January 12, 2001

The Egyptian Civil Aviation Authority requests and authorizes you to place the Response of EgyptAir to October 31, 2000 Submission of The Boeing Company regarding the EgyptAir Flight 990 investigation into the public docket for the EgyptAir Flight 990 investigation.

Response of EgyptAir  
to  
October 31, 2000 Submission of  
The Boeing Company  
Regarding  
The EgyptAir Flight 990 Investigation

Figure 11. Pitchover Simulation, Right Elevator Missing

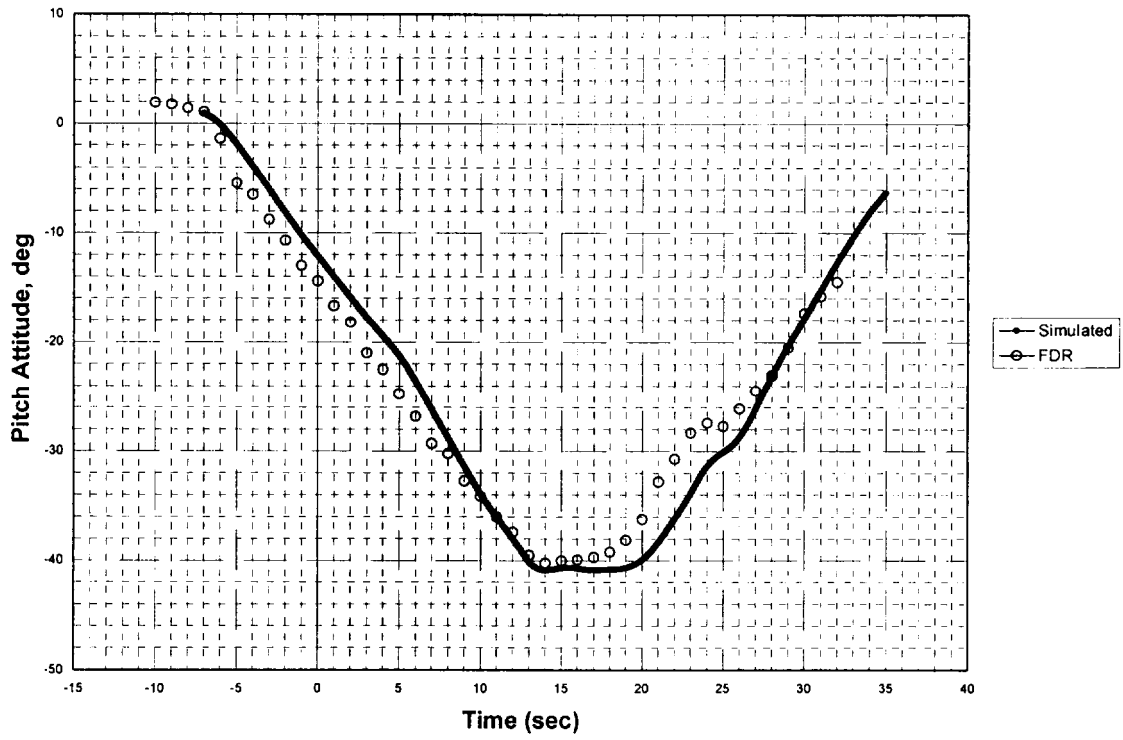
The results in Figure 11 are calculated assuming that the right tailplane was no longer producing a lift increment due to deflection of the right elevator. The maximum nose down pitch angle agrees very well with FDR data, and the simulated pitch begins to recover very closely in time to the FDR pitch attitude.

Figure 15. Aileron Position from B-767 Ground Test Results Extracted from Boeing CD

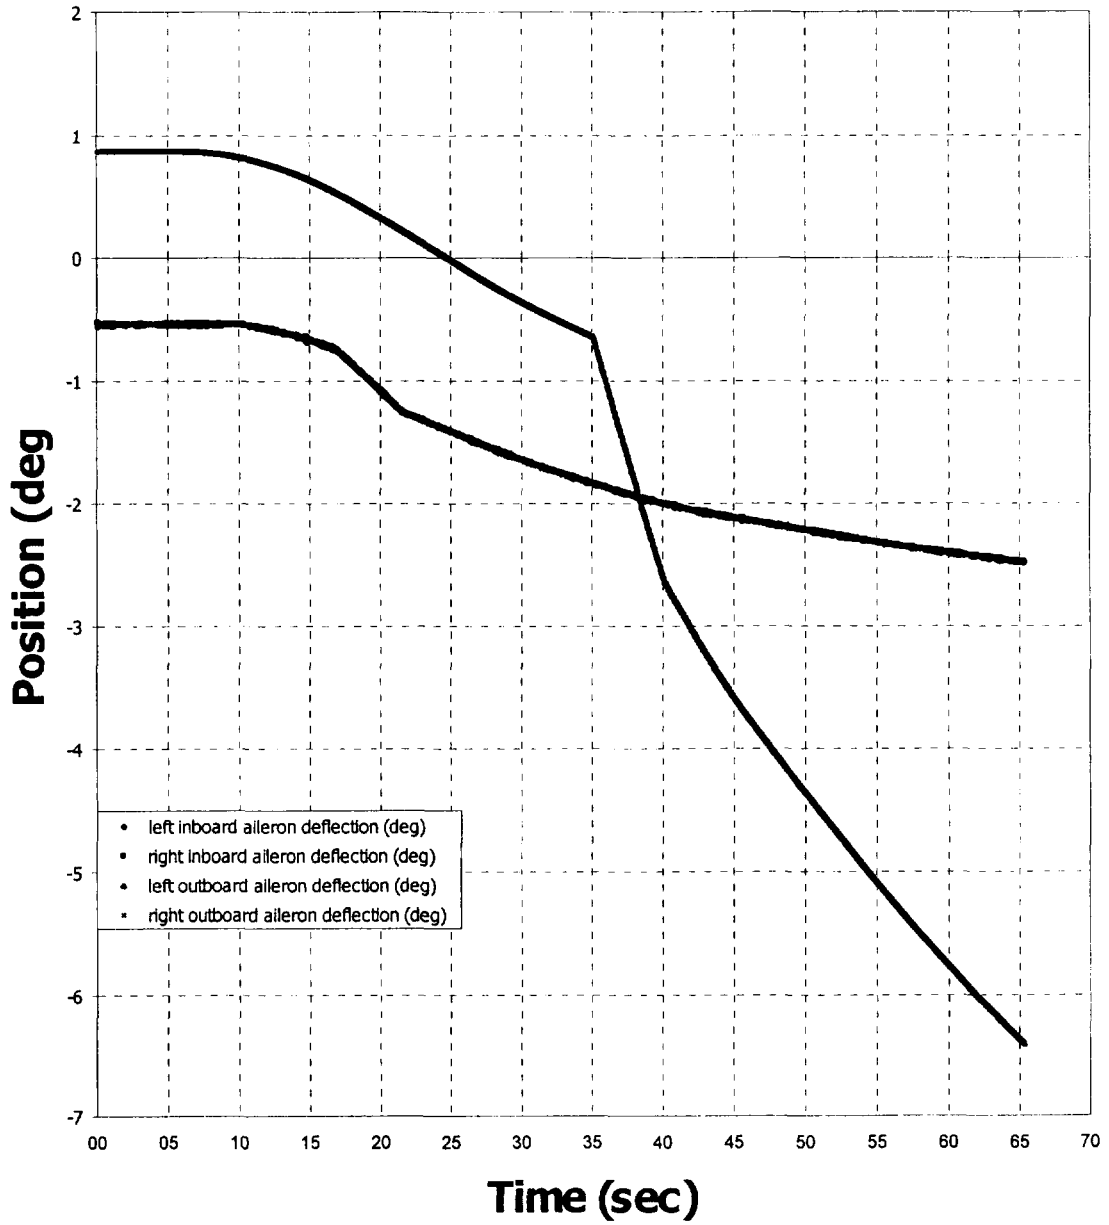
- The E-Cab data produced an unrealistic relationship between control wheel force and wheel movement (see Figure 14) and showed the movement of the outboard ailerons at speeds beyond the lockout speed (see Figure 15).

Figure 24. March Ground Test Data, Bias Changes for Captain and First Officer Column Force Measurements

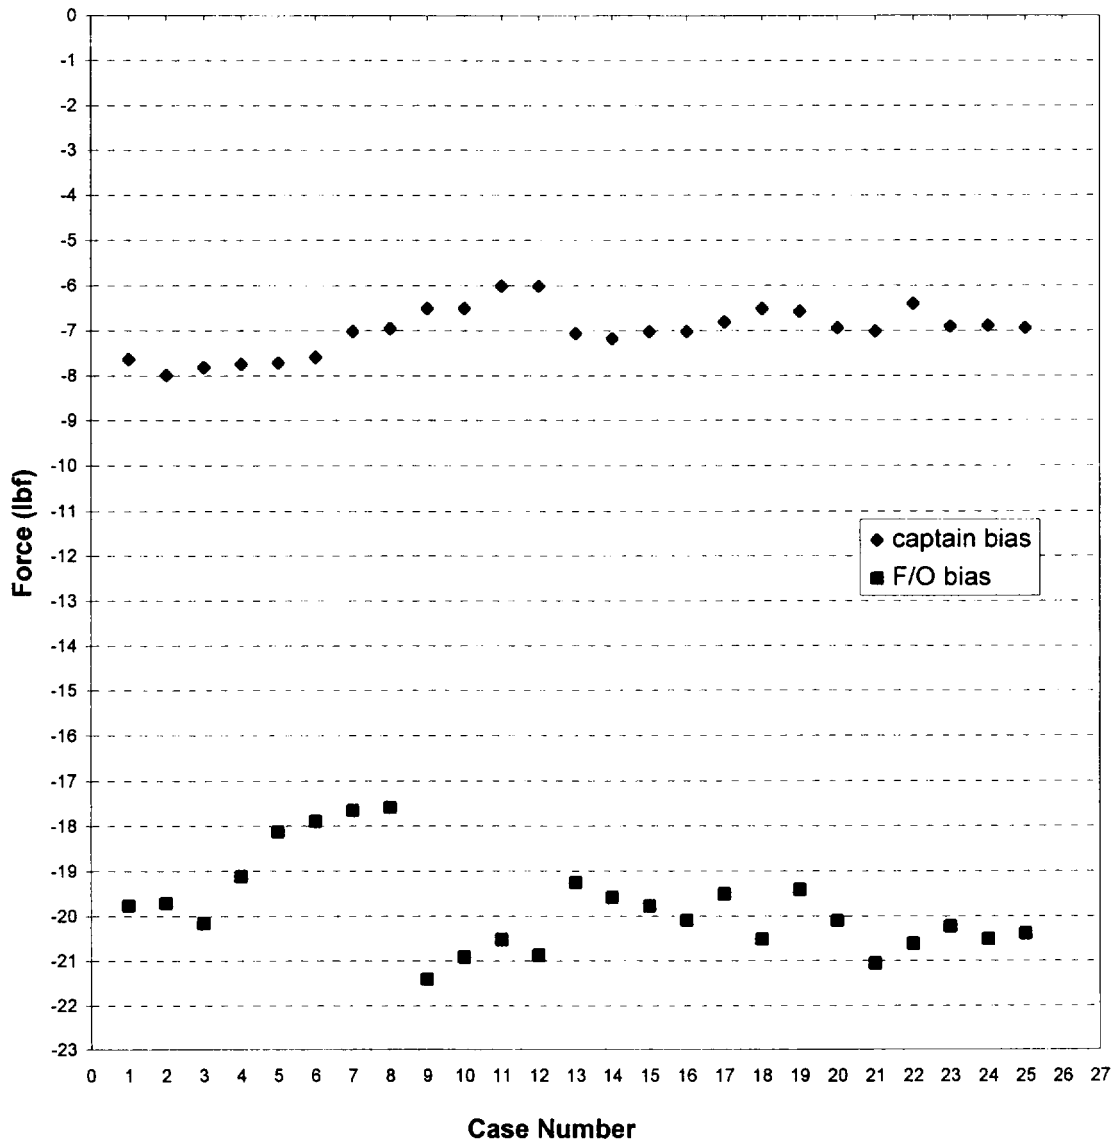
Further, Boeing's explanation of force bias due to temperature effects is not supported by the data. Figure 24 shows the bias on the Captain's column force measurement increasing with time, with the suggestion that changes in temperature caused this change in bias. If temperature were the cause of the change in bias, the bias in the First Officer's force measurement would have increased as well, but it decreased. In addition, the bias on the First Officer's force measurement does not change in the nearly linear manner that the bias on the Captain's force measurement does. If both force transducers have the same specifications, they should react to temperature in a very similar manner; there should not be an opposite reaction to changes in temperature.

Figure 25. April Ground Test Data, Bias Changes for Captain and First Officer Column Force Measurements

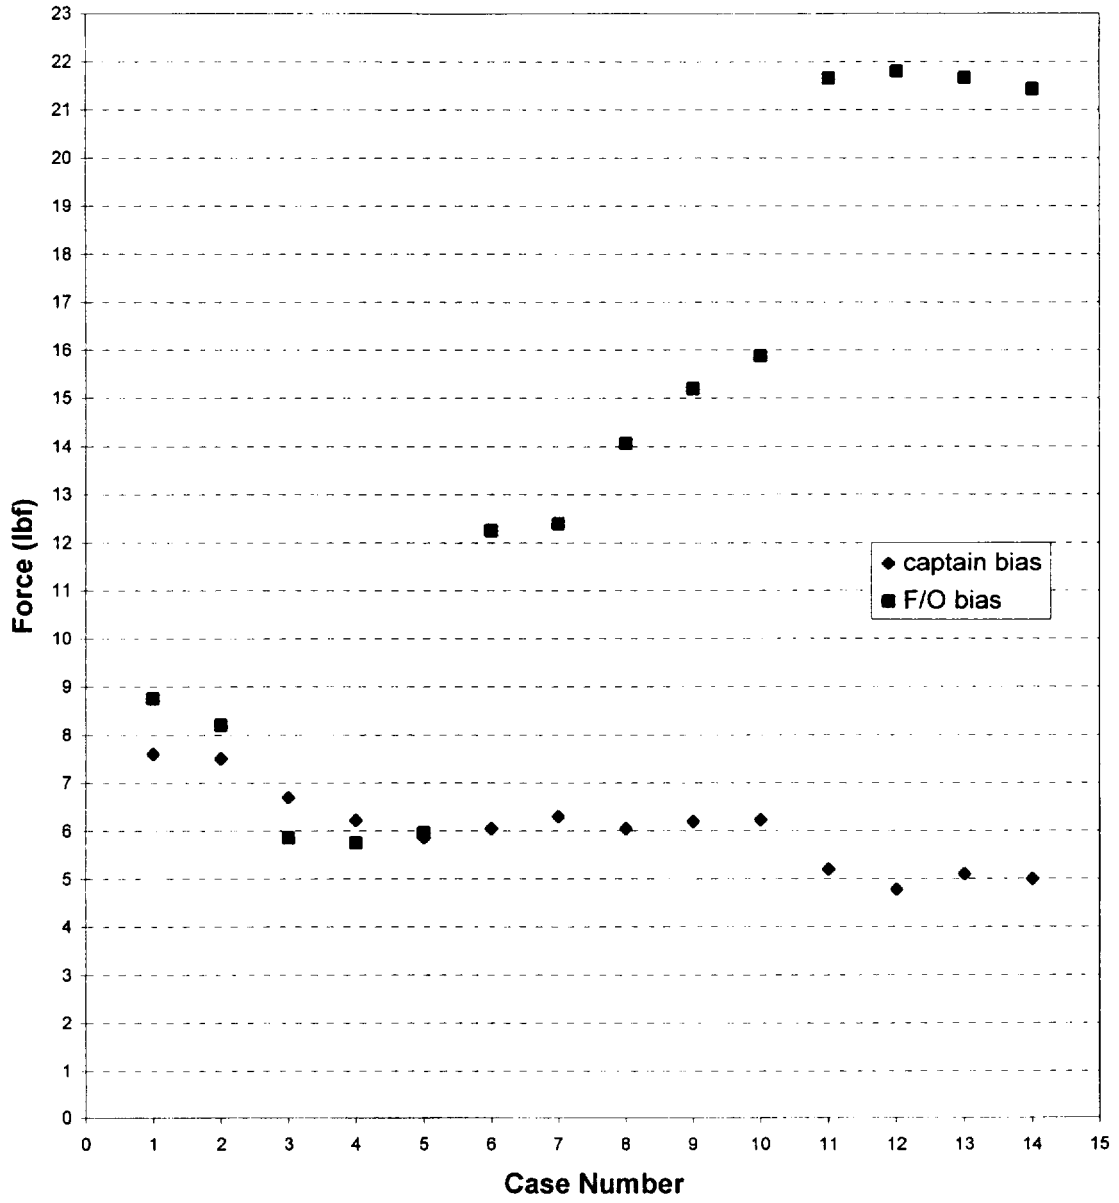
Figure 25 shows the bias during another test, but this time, the bias on the First Officer's force measurement increases much more rapidly than in the earlier test. This suggests that the temperature effects on the transducers are random because the temperature dependence more than triples between tests. Even if the temperatures had been recorded during the tests, that

information would not have been useful for calibrating the force measurement because of the apparently varying temperature coefficients.
